## **ADDENDUM # 1**

DATE: May 23, 2025  
TO: Potential Respondents  
FROM: Elaine Robbins – Construction Contract Coordinator II  
SUBJECT: RFCSP752-25-1010ER  
UNT Discovery Park D170 Research Lab Buildout

## ADDENDUM NO. 1

**PROJECT:** UNT Discovery Park D170 Fit-Out  
HE0569.2402.00

**S2.03**

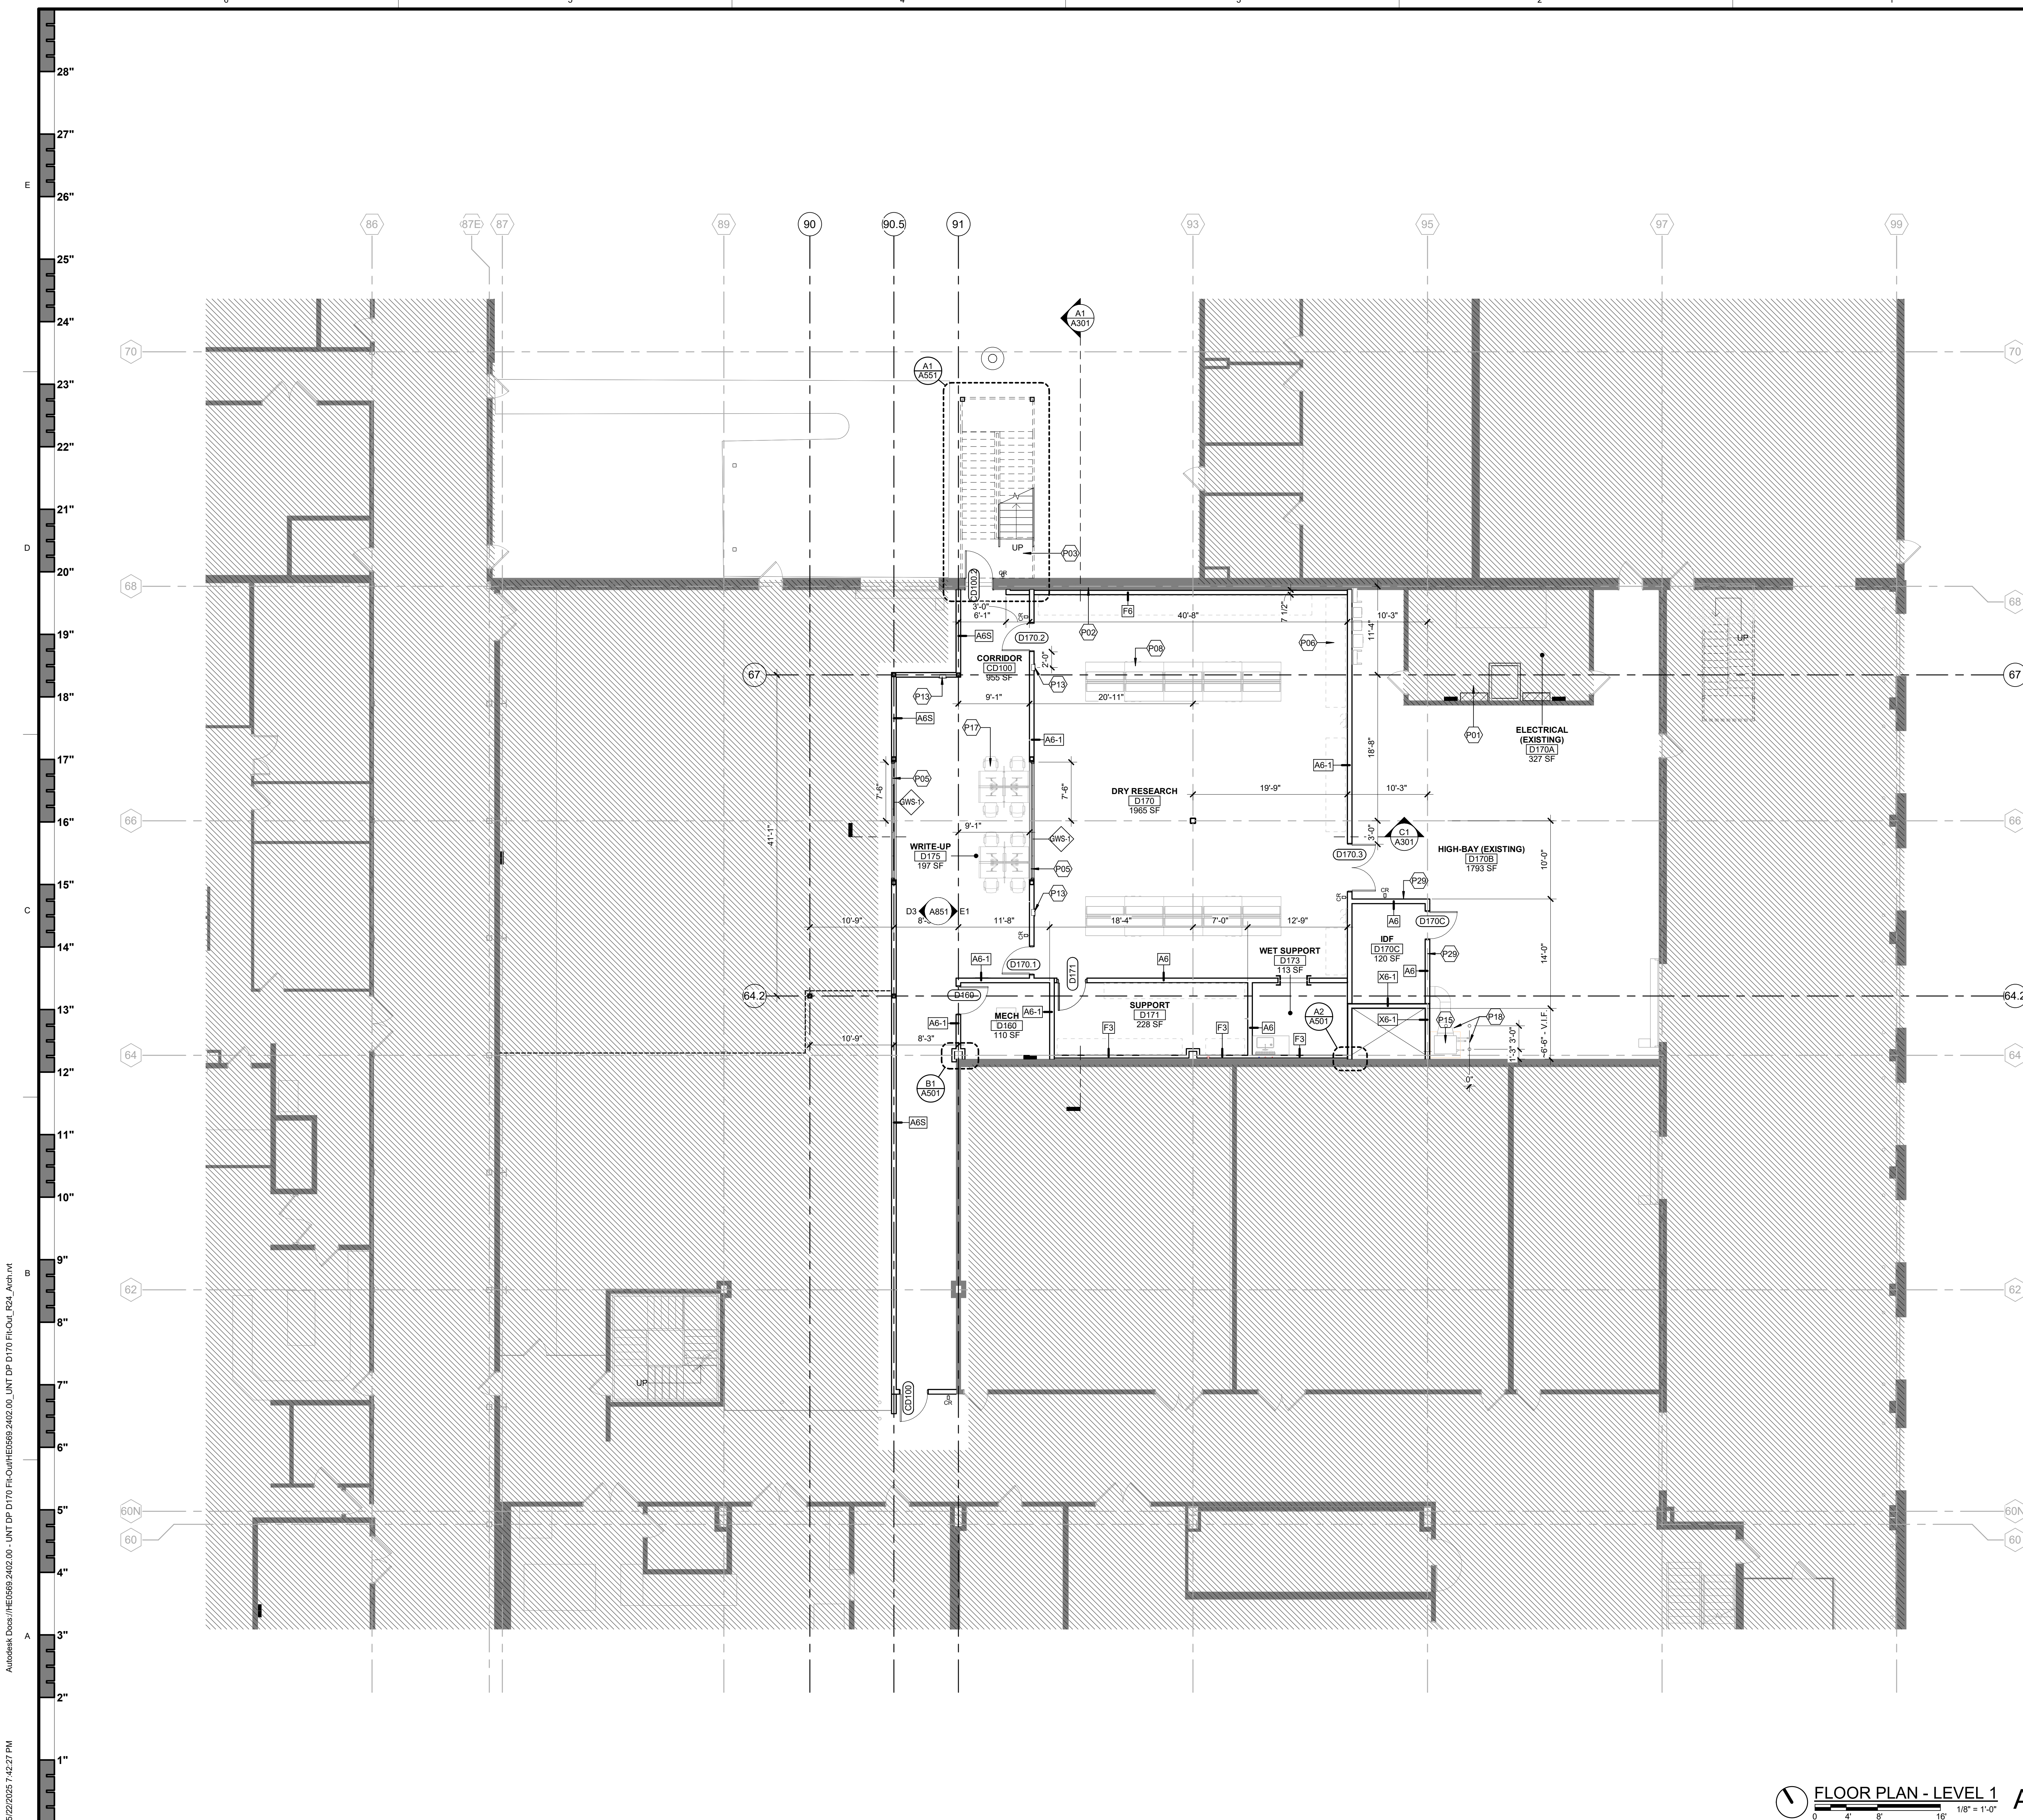
ITEM	DETAIL
	<p><u>Sheet S2.02 – FRAMING PLAN</u> Column gridline 64.5 renamed to 64.2 to match Architectural. W10x12 beam added to support the level 2 shaft wall partition.</p> <p><u>Sheet S2.03 – ROOF FRAMING PLAN</u> Column gridline 64.5 renamed to 64.2 to match Architectural.</p> <p><u>Sheet A101 – FLOOR PLAN – LEVEL 1</u> General note “L” has been removed.</p> <p><u>Sheet A102 – FLOOR PLAN – LEVEL 1</u> Wall type, dimension by fume hoods clarified. General note “L” has been removed.</p> <p><u>Sheet A151 – REFLECTED CEILING PLAN – LEVEL 1</u> Light fixtures in room D160 updated to match Electrical. Outlet locations updated in linear ceiling service panels.</p> <p><u>Sheet A152 – REFLECTED CEILING PLAN – LEVEL 1</u> Outlet locations updated in linear ceiling service panels. Ceiling supply diffuser locations updated.</p> <p><u>Sheet A501 – INTERIOR DETAILS</u> Detail C1/A501 updated to clarify card reader rough-in at doors.</p> <p><u>Sheet A601 – DOOR SCHEDULE, GLAZING TYPES, AND DETAILS</u> Glazing notes updated to reflect clear tempered glazing as opposed to laminated glass. Door finishes updated on all SCW interior doors. Door lite light in type “N” door has been dimensioned.</p> <p><u>Sheet A700 – INTERIOR FINISH SCHEDULES AND DETAILS</u> Acoustical Panel Ceiling product basis-of-design has been revised. LGL-1 revised to be GL-1, reflecting clear tempered glazing as opposed to laminated glass. TS-1 revised to VPUL 50 ACGB. WD-1 wood veneer added as door finish on interior SCW doors.</p> <p><u>Sheet A710 – FINISH PLAN – LEVEL 1</u> Note P18 revised to reference the correct detail. Corner guards added to gyp framed wall opening.</p> <p><u>Sheet A711 – FINISH PLAN – LEVEL 2</u> Keynote legend added to sheet.</p> <p><u>Sheet A805 – LINEAR SERVICE PANEL DETAILS</u> Linear service panel outlet locations and quantities adjusted.</p>

A700

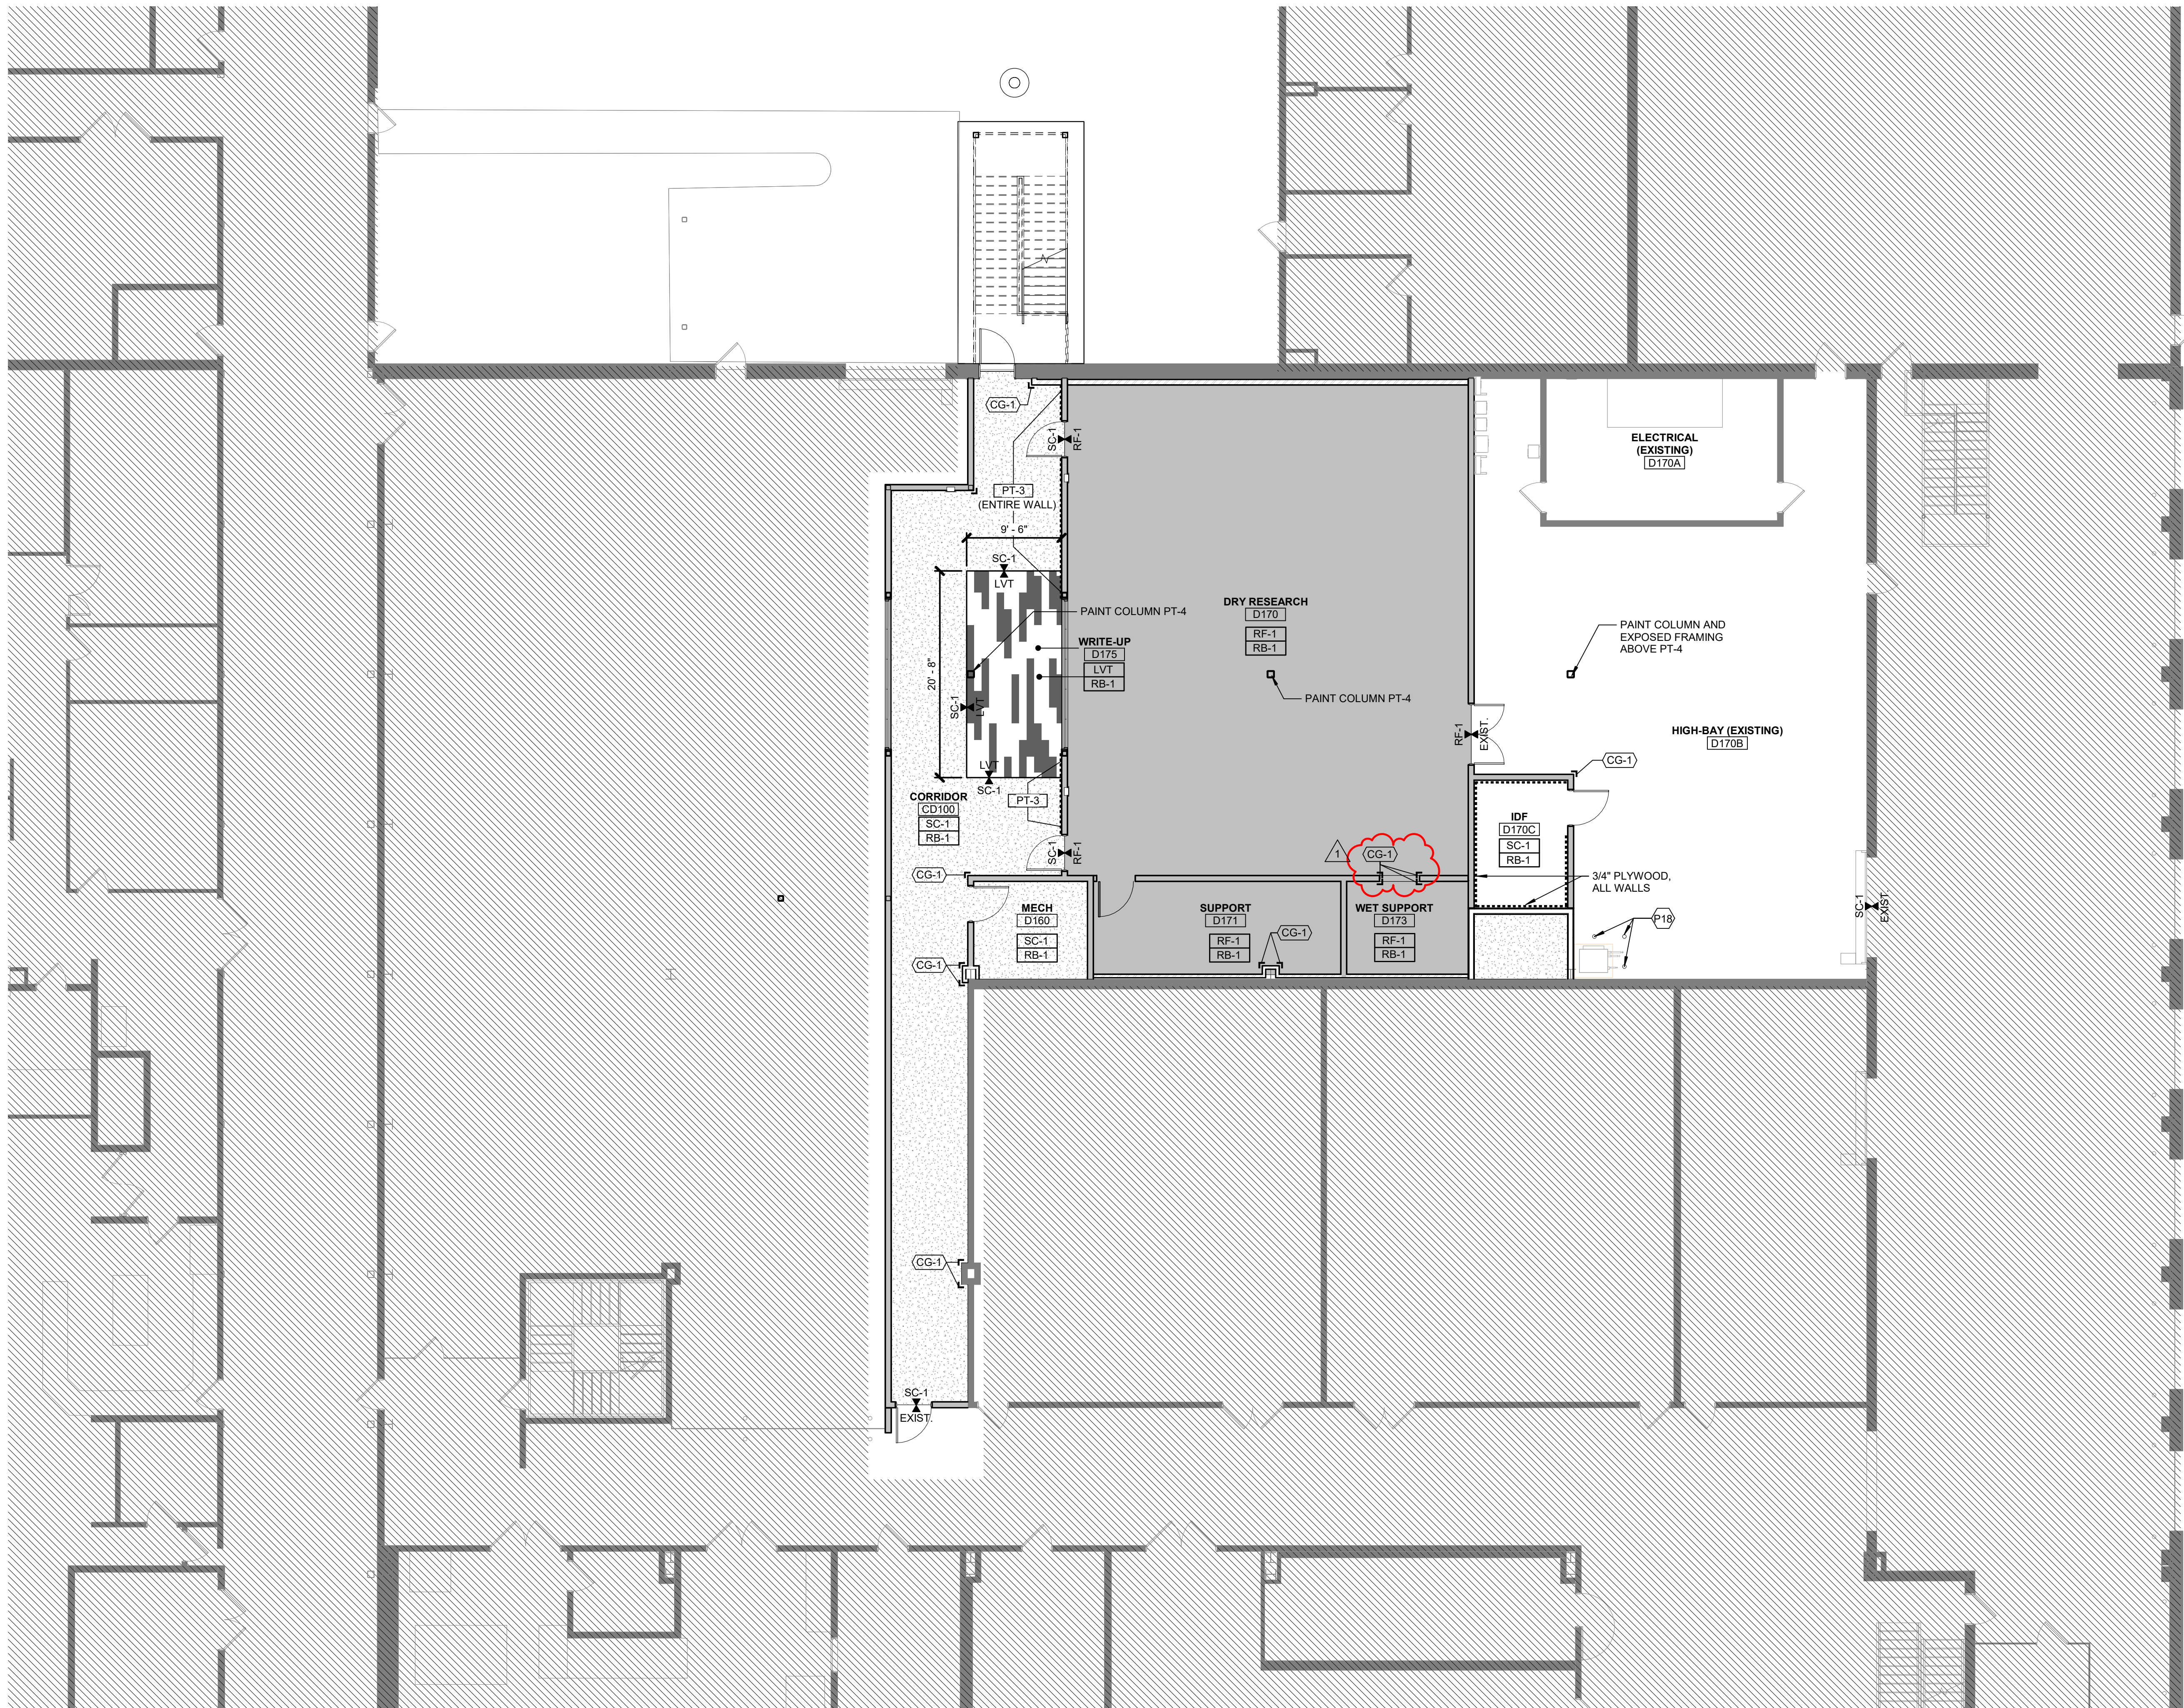
1.51	<p>Q: Please provide a spec section for LVT-1 and LVT-2.</p> <p>A: <b>Spec Section 09 6519 is updated in this addendum</b></p>
1.52	<p>Q: Spec section 096519-2.02-E indicates RF-1 size to be 40"x40". Interior Finish Legend on sheet A700 indicates RF-1 size to be 24"x24". Please clarify.</p> <p>A: <b>Spec Section 09 6519 is updated in this addendum</b></p>

1.53	<p>Q: Spec section 096513-2.01-H indicates RB-1 color to be 699 Battleship. Interior Finish Legend on sheet A700 indicates RB-1 color to be 29 Moon Rock WG. Please clarify.</p> <p>A: <b>Spec Section 09 6513 is updated in this addendum</b></p>

1.54	<p>Q: Spec section 033500-2.02-A-1 indicates to see section " " for information on the penetrating concrete sealer. No section is listed. Please provide.</p> <p>A: <b>Refer to Finish Legend A700 for sealer information</b></p>
